Documentation Description: Nonconformance Report - C-01006

# NONCONFORMANCE REPORT

C-01006

Watertight doors & frames

Door 32 (C)

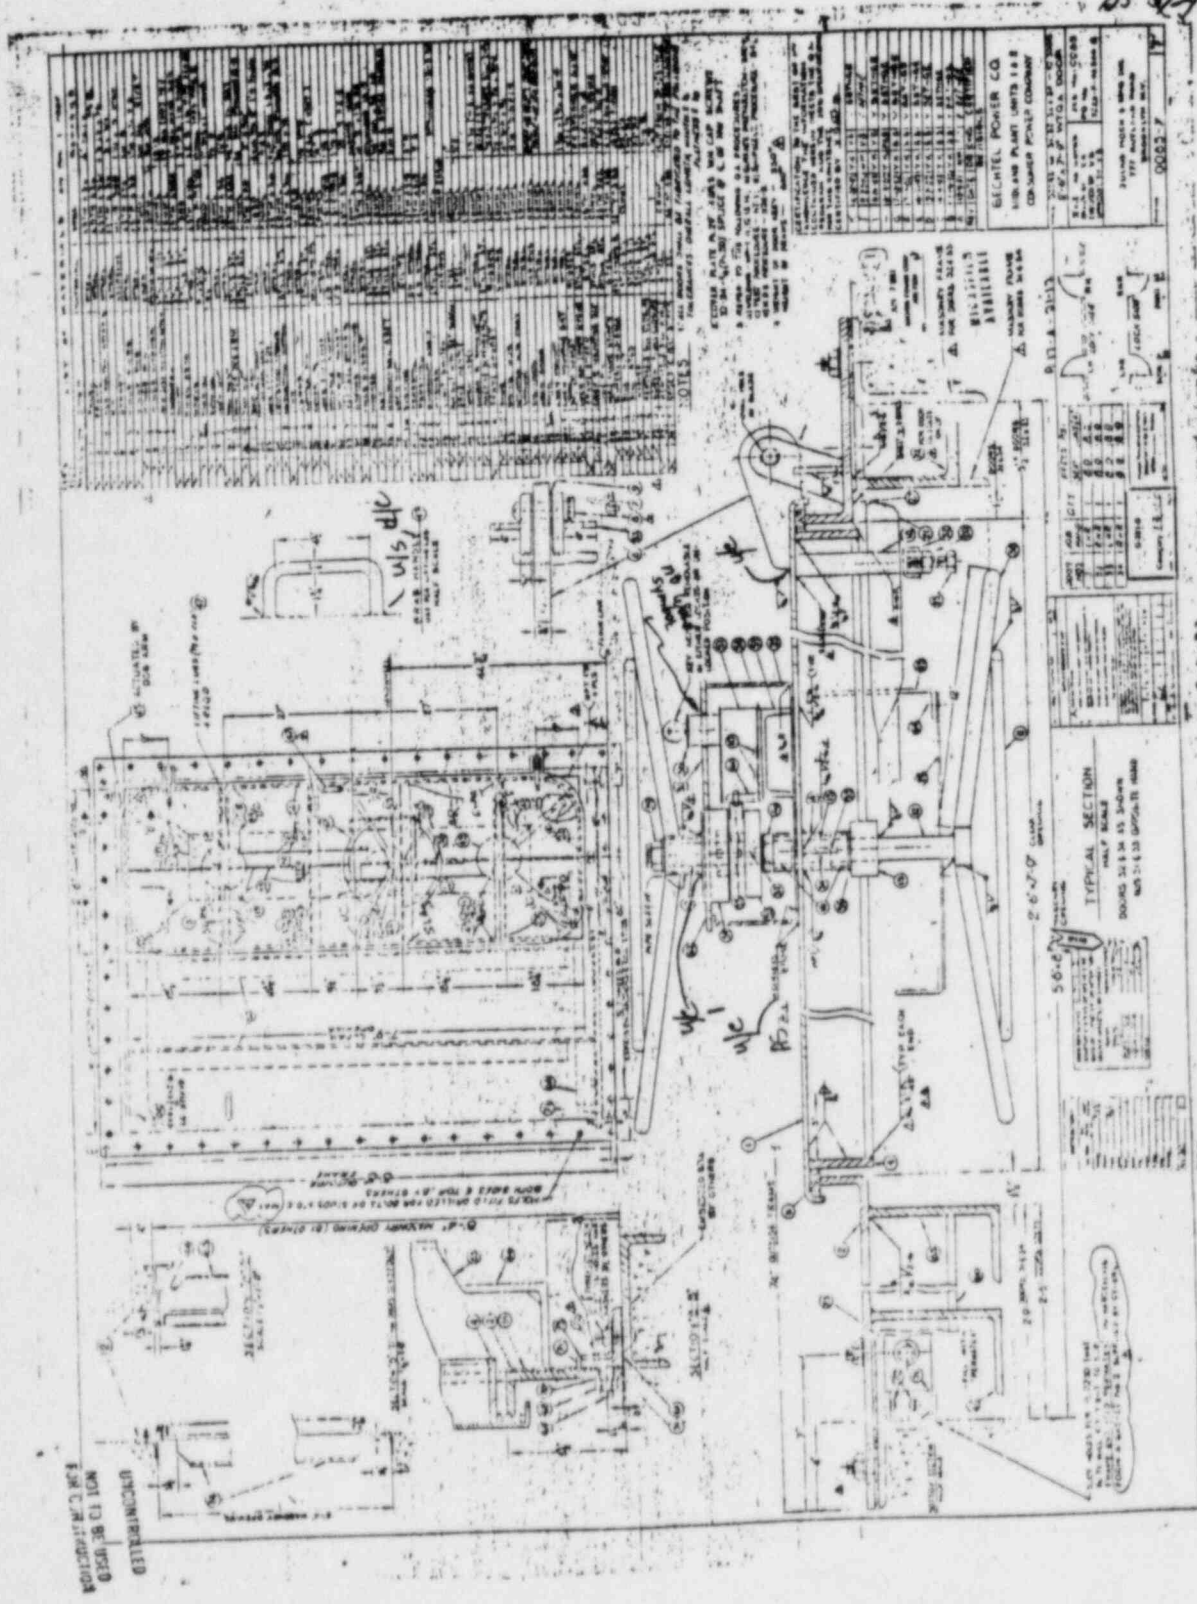
u/c - undercar  
 A/S - arc strike  
 W/S - under size

Door #34 (C)

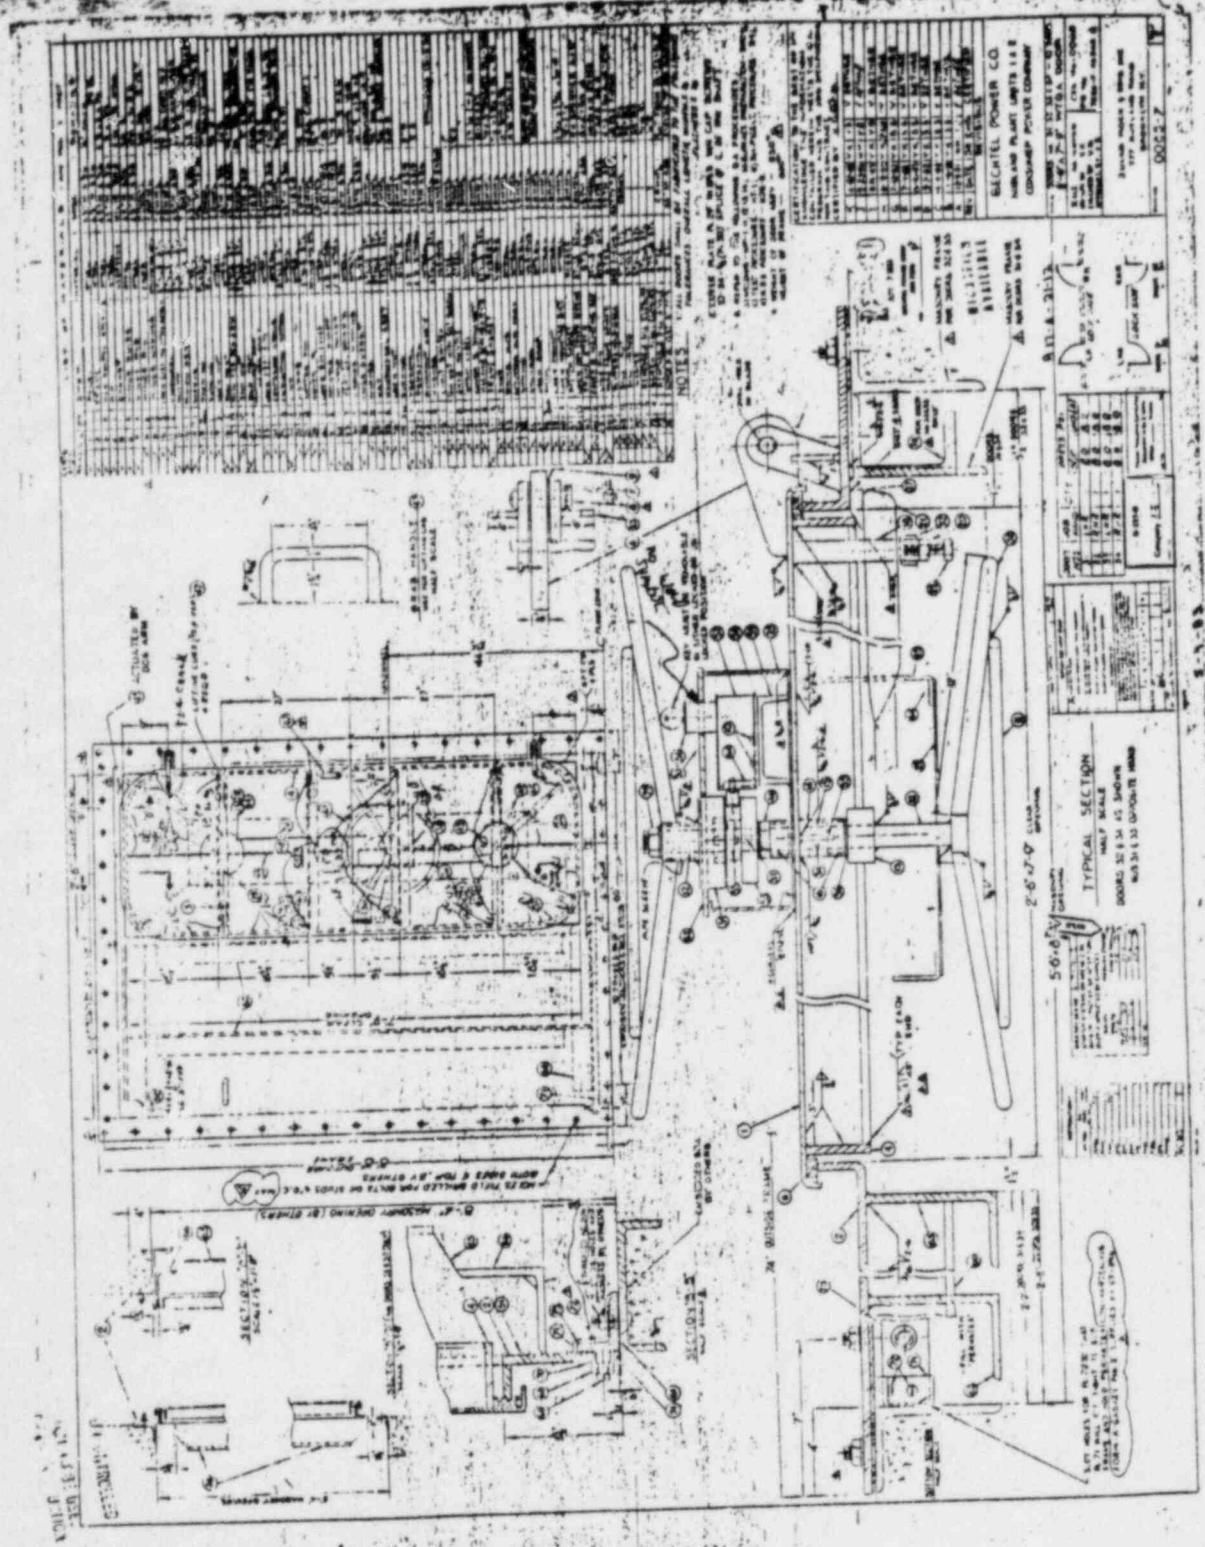
u/c = undercut  
P.O. = porosity  
C.R. = cold roll / lap  
L.F. = lack of fusion

Door #33 ©

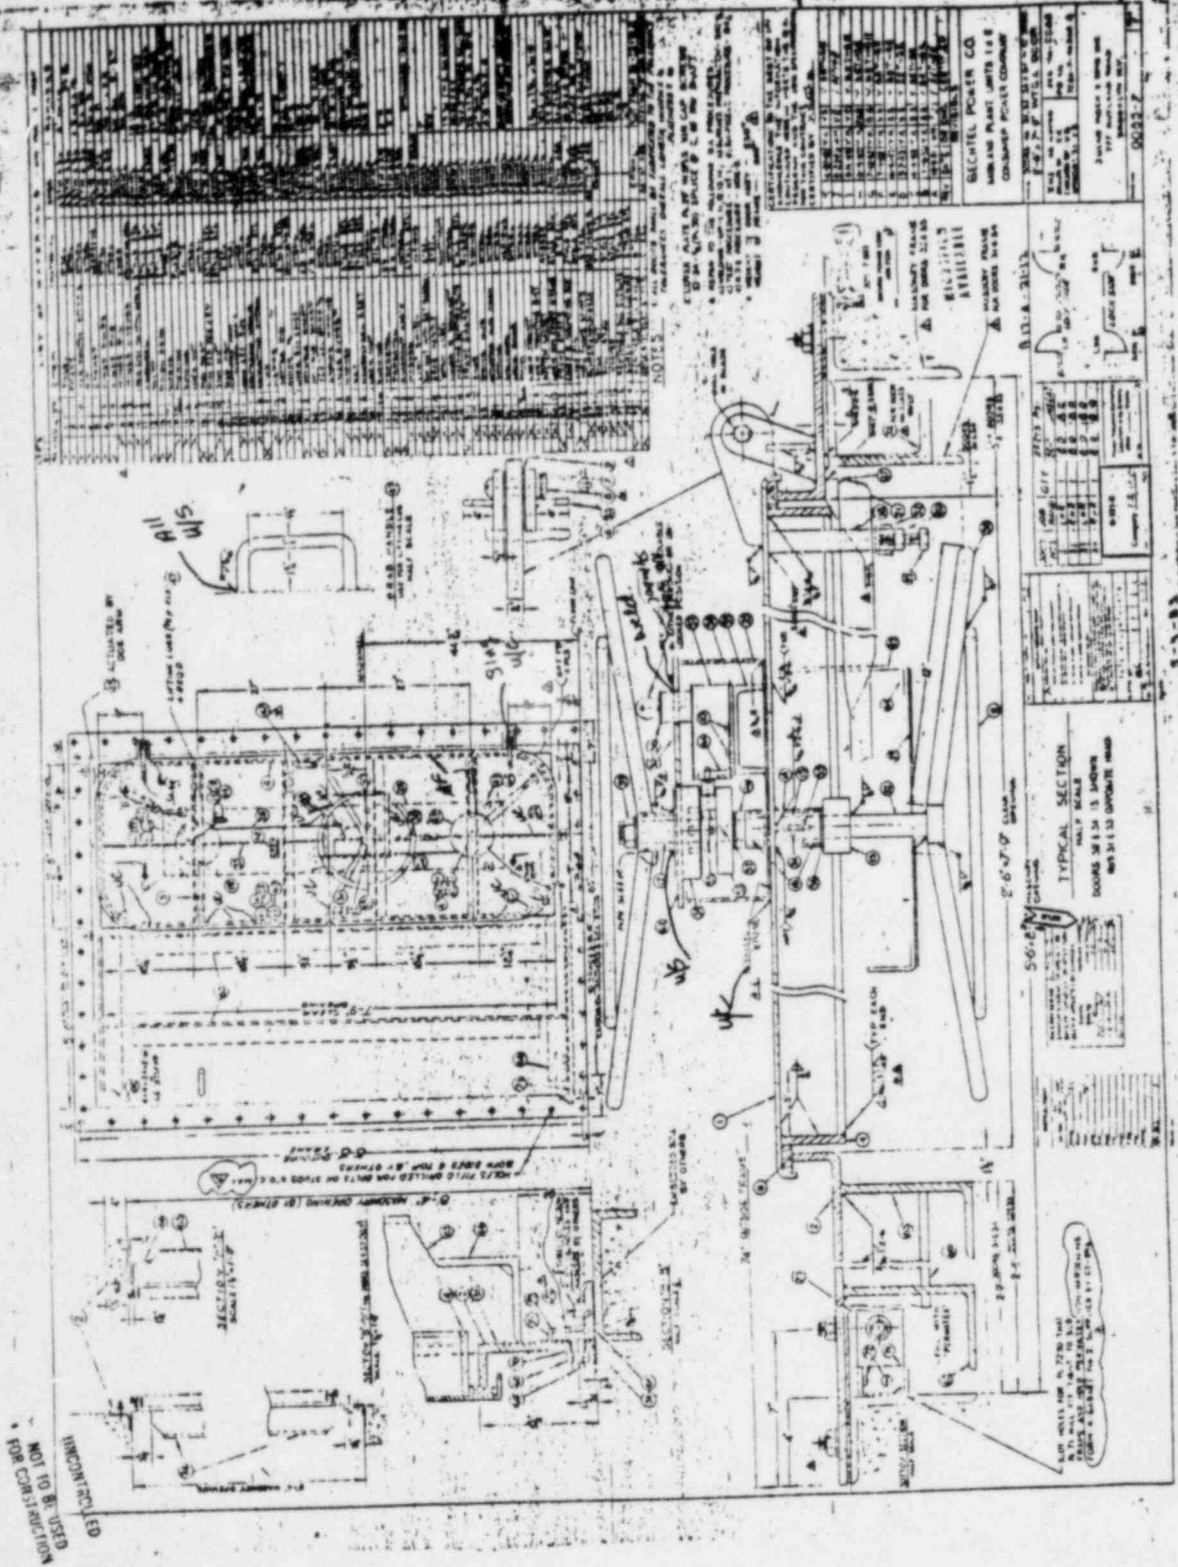
W/C = under cut  
 U/S = under size  
 L/P = lack of fusion
